Re: 49 CFR Part 573; Recall of Mercedes-Benz C-Class (203) Driver Air Bag

Campaign No. 2006020005. March 2006

SUBJECT: MODEL 203, MODEL YEAR 2005-2006

REPLACE DRIVER AIRBAG

Figure 2

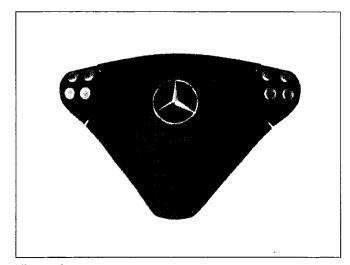
- 5. Remove orange connector locks (arrows, Figure 2).
- 6. Disconnect green (A) and yellow (B) squib electrical connectors.
- 7. Disconnect multifunction steering wheel electrical connector (C).
- 8. Remove airbag.
- 9. Install new airbag (Figure 3) in reverse order.
- 10. Connect battery ground cable.
- 11. Check function of new steering wheel switches and horn.
- 12. Connect Star Diagnosis; read out and erase fault codes and event memory.
- 13. Disconnect Star Diagnosis.
